**From:** [REDACTED]  
**To:** [REDACTED]  
**Sent:** 4/5/2021 8:30:39 AM  
**Subject:** FW: O8W-PM 35217268, 35224712, 35224713 - Bucks Creek 1101 Phase 1,2&3 - Pre-Engineering Meeting

Subject: O8W-PM 35217268, 35224712, 35224713 - Bucks Creek 1101 Phase 1,2&3 - Pre-Engineering Meeting

PM 35217268 (Phase 1)

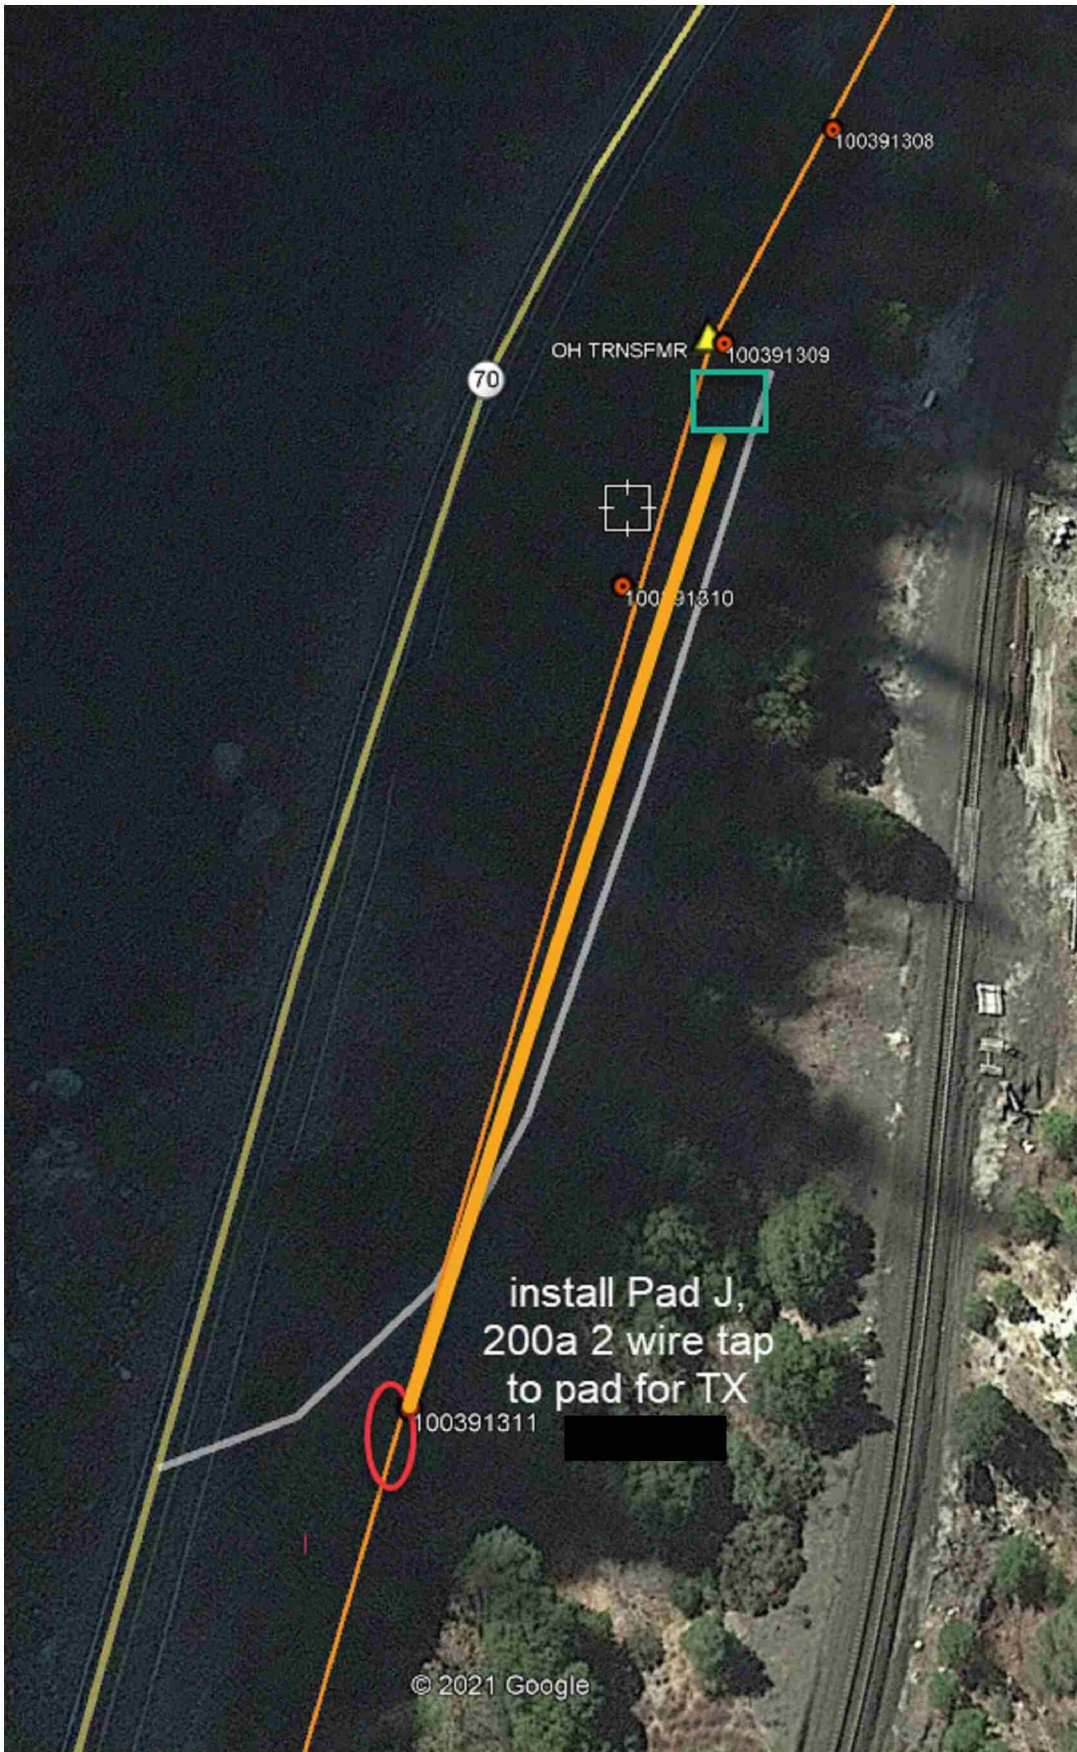
Your outlet red-line Bucks Creek looks close to what I was thinking. Need to work with [REDACTED] to get this designed with a single 6" and use #5 boxes with 200A cable. There is not a reason this will need (2) 6" and 1-4" and 7 boxes. There is probably only 20a peak on the primary now.

Also need to see what Hydro is willing to do with the TX for the penstock metering valve at Rock Creek PH. It will be a long way up from the

Need to see if Hydro has GPR data for the Hwy 70 road bed to see if we can get 42" minimum cover and keep clearance over any hydro facilities.

Merlin can go back like we just did [redacted] Poe. Pad on the Highway and tension secondary 1/0 ASCR across the river. We can negotiate to move the [redacted] service point with my MSA electrician.

we can serve [redacted] Merlin with either circle, OH 1/0 ASCR triplex tension across the river.

Should be able to take a pad here and get the dam a UG service. For Cal trans riser up and go in the back of the

first tunnel window, leave the old TX pole, top it and use to splice in UG service feed.

PM 35224712 (Phase 2)

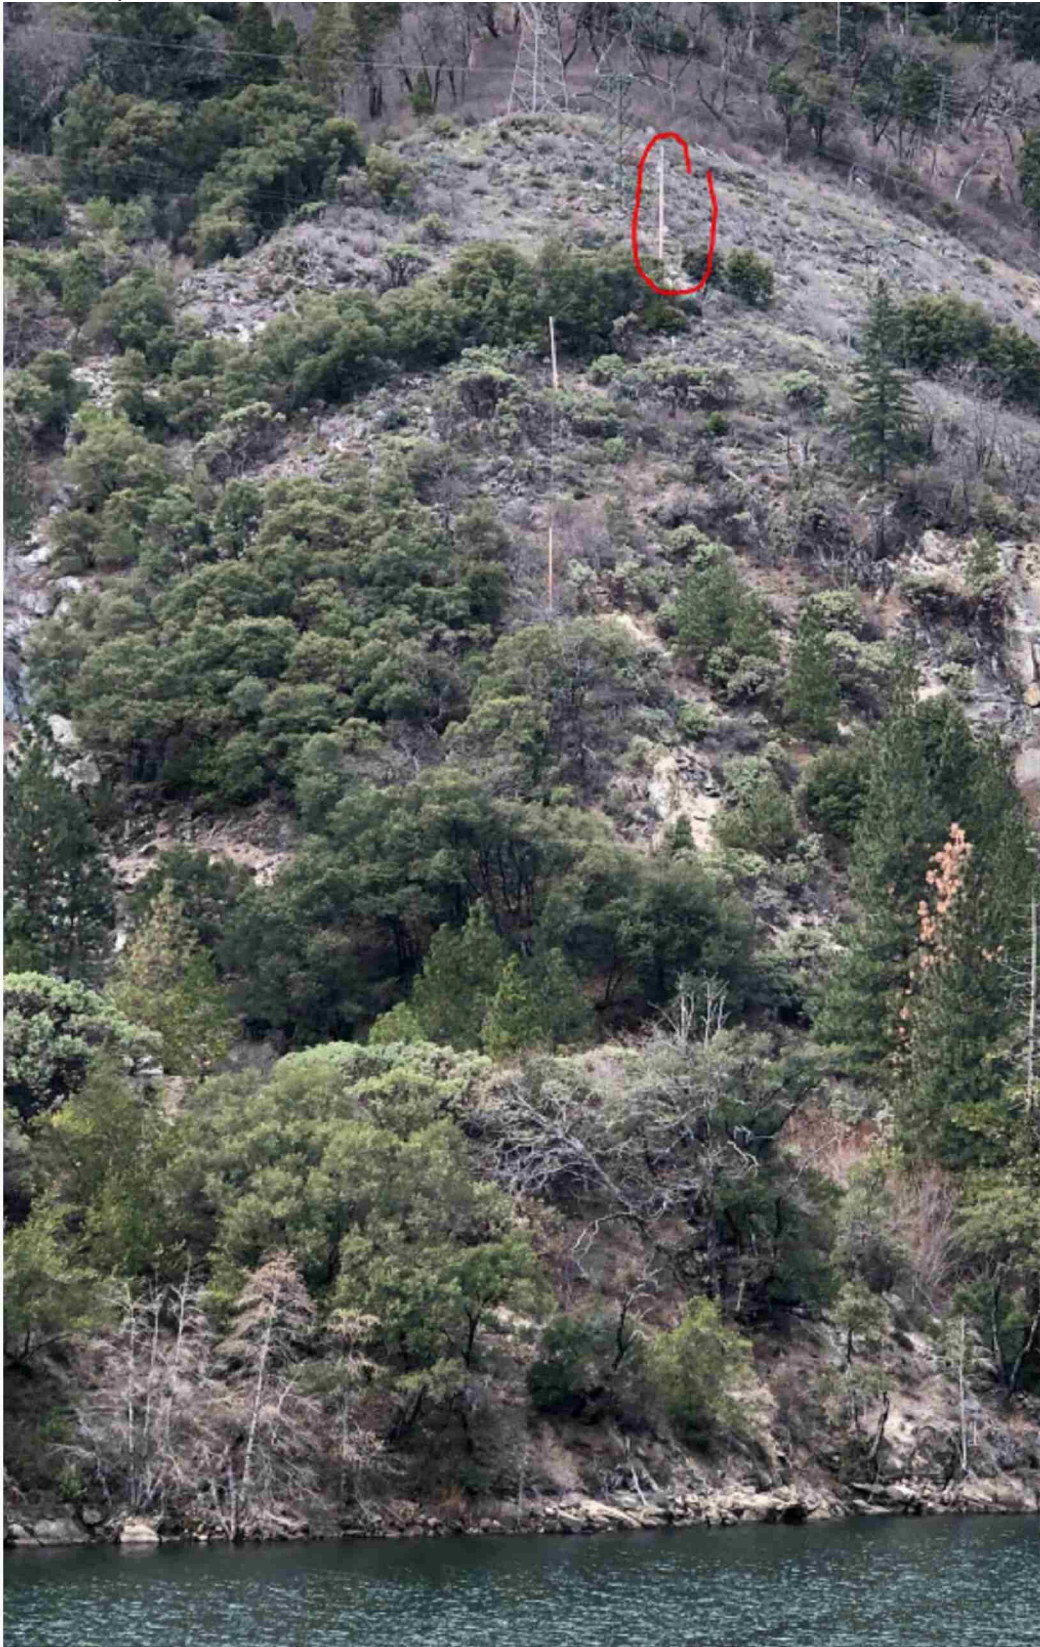
1. Preliminary Drawing was not provided
2. Trench Location:
  - a. We determined that landing the trench ~2' into the lane from the ETW (fog-line) was probably the best consistent location of which it would be ideal if the 7-boxes could be landed in the 'travel lane'. This will need to be discussed with Caltrans before moving forward with the design.
  - b. Any proposed poles to be placed within 52' from ETW if absolutely needed will need 'gaurdrail' protection to assist with DSDD exception requests.
3. Rock Creek Bridge Crossing
  - a. Scope is not clear for this crossing since it leads us to a 'what-if' scenario of, if Caltrans doesn't allow the conduits to be attached to the existing bridge we should span the river OH. This will need to be discussed with Caltrans to first determine 'if' we can attach to their bridge before scope is locked.
